<u>ZC-20-026</u>

#### ZONING MAP CHANGE STAFF REPORT

BGE	<b>BGE, Inc.</b> 777 Main St., Suite 1900, Fort Worth, TX 76102 Tel: 817-887-6130 • www.bgeinc.com TBPE Registration No. F-1046				
SHIP 01 - 8681 North Beach					
REGATTA 55 @ 8681 N BEACH ST. PD SITE PLAN					
scale: 1 <b>" = 50'</b>	JOB #: <b>7390-00</b>	DATE: FEB 2020	EXHIBIT:

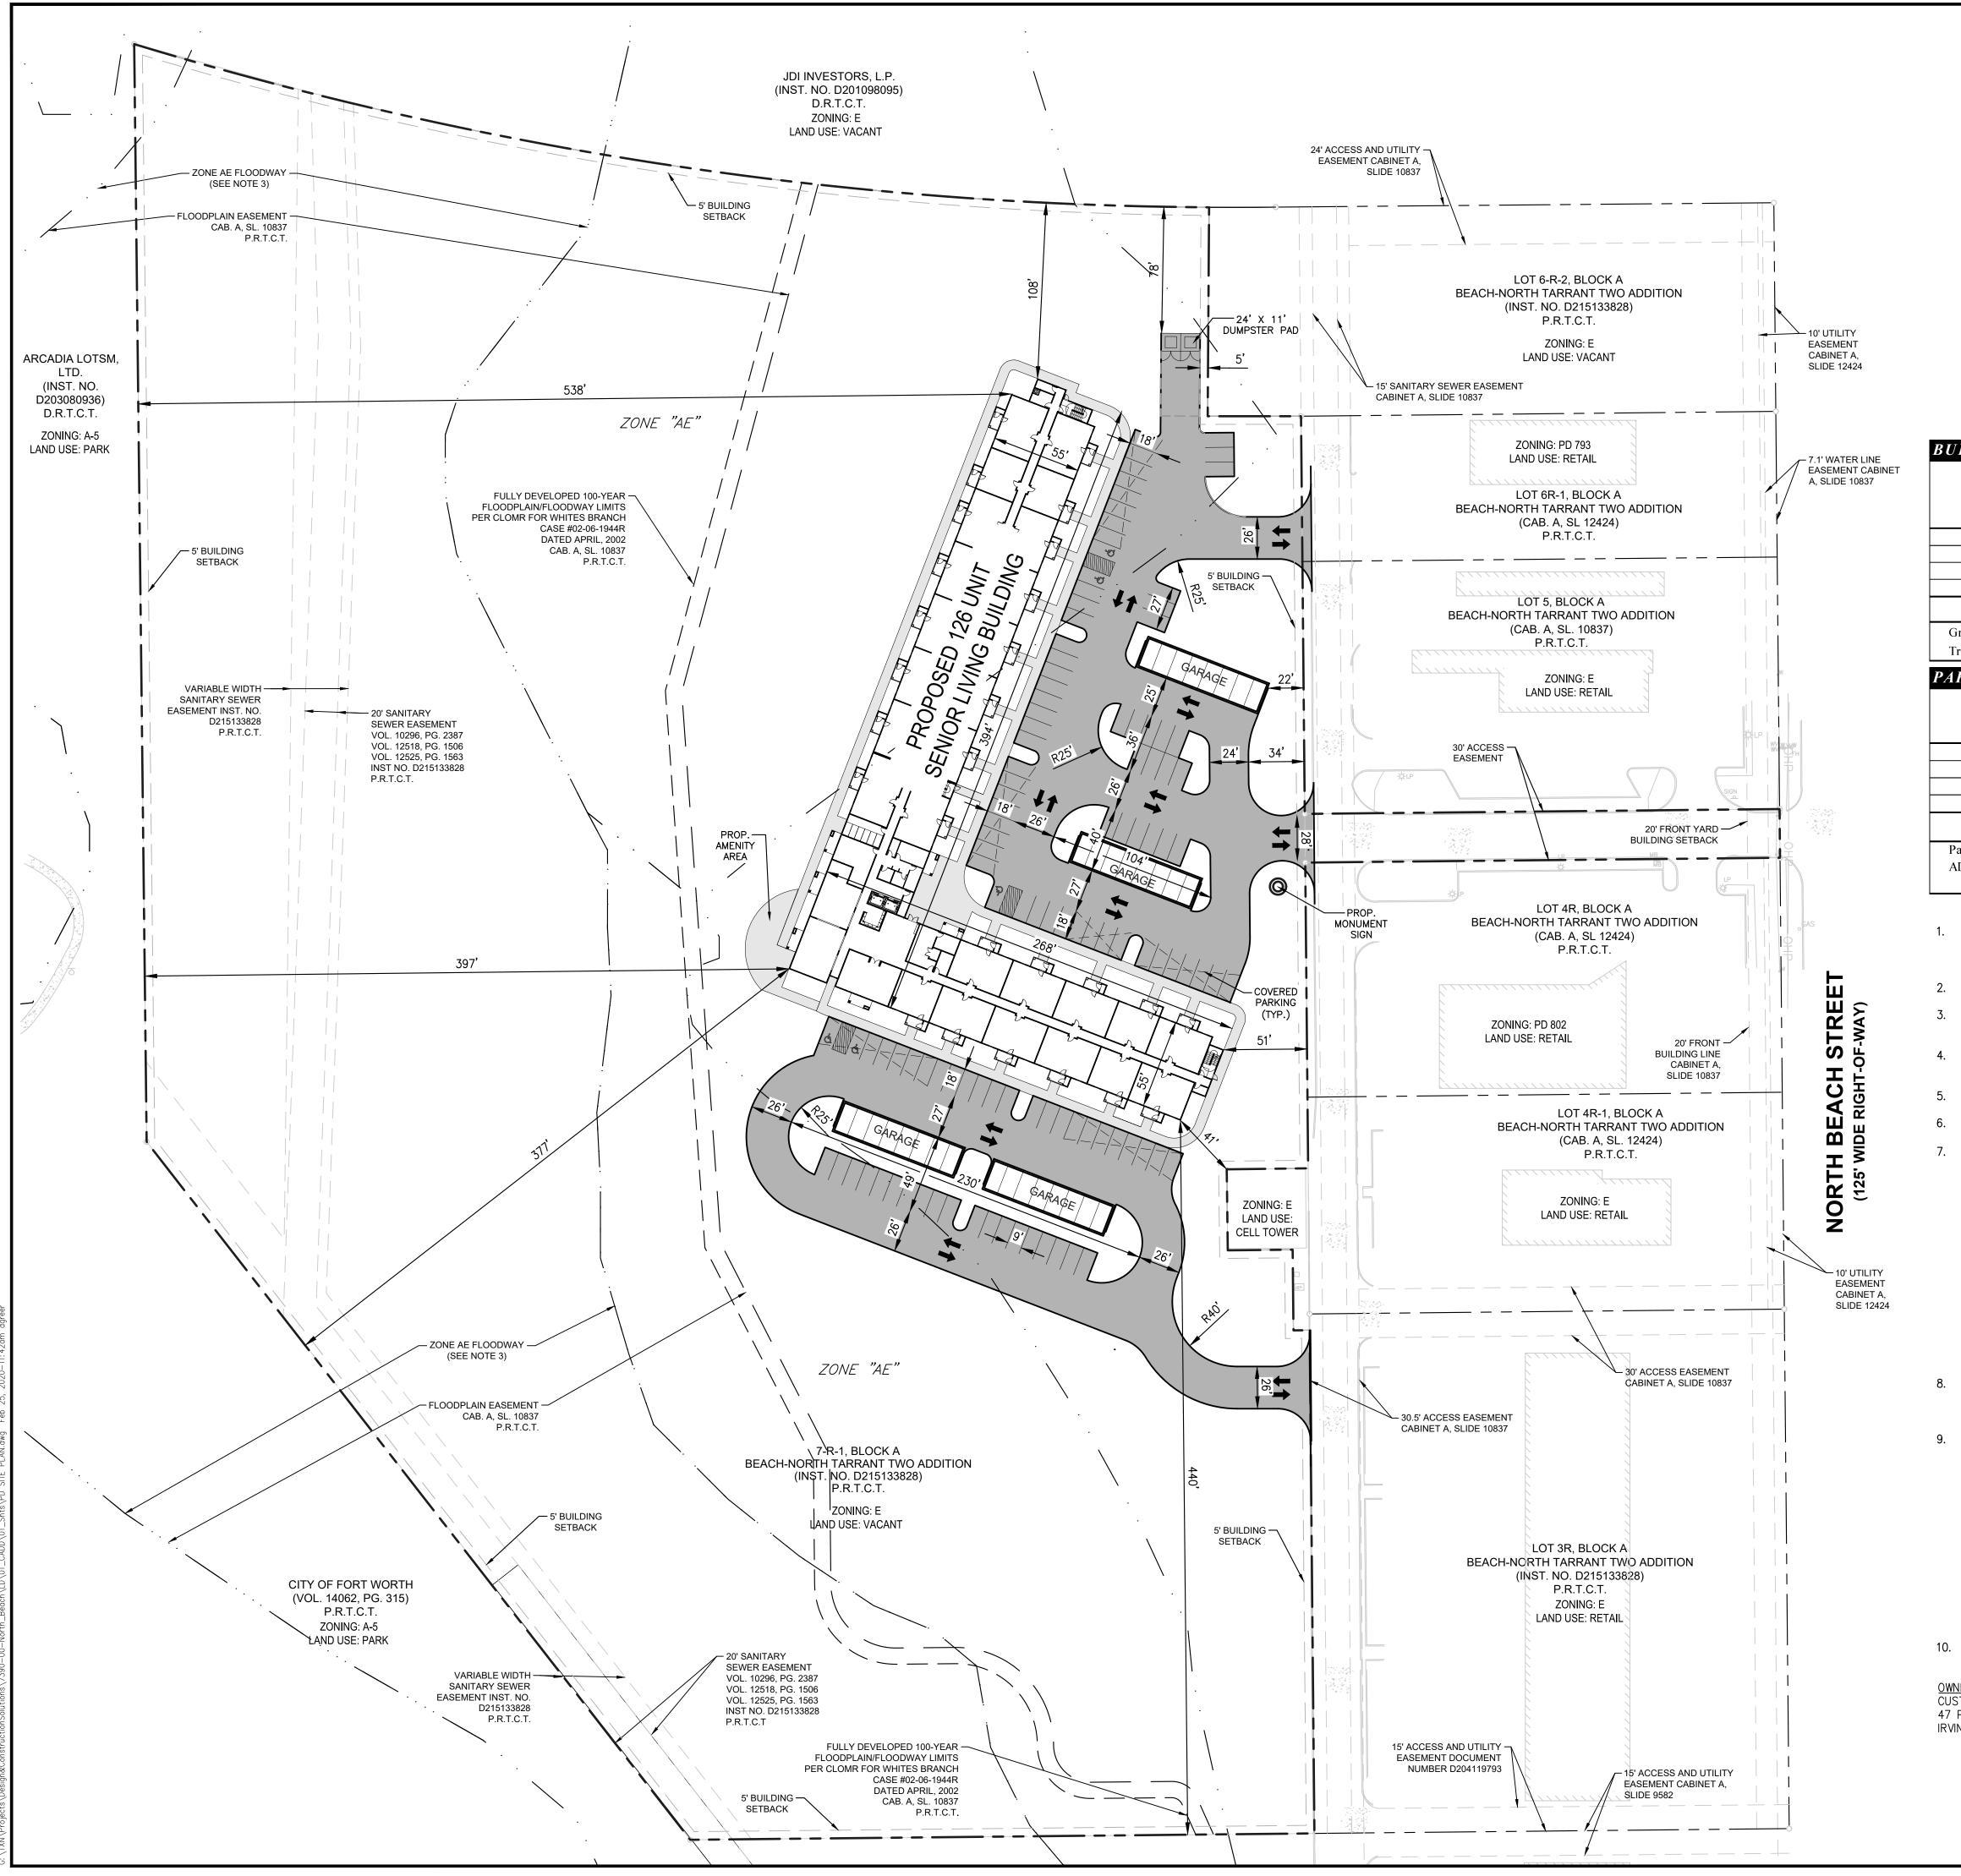
The site plan as submitted is <u>not</u> in general compliance with the Zoning Ordinance regulations.

- 1. The applicant is asking for a waiver to the MFD site plan submittal (waiver required)
- 2. Maximum height is 36. The site plan indicated 48' (waiver required)
- 3. Per Section 4.712 a minimum 6 foot screening fence shall be placed on the property line when adjacent to a one- or two- family residential district. A fence is not proposed on the western property line (waiver required)
- 4. Parking is not allowed between a building and a public or private street (waiver required)
- 5. The parking ratio is 1 space per bedroom plus 1 space per 250 sf of common space, which would require 220 space. The site plan indicated 144 spaces (waiver required)
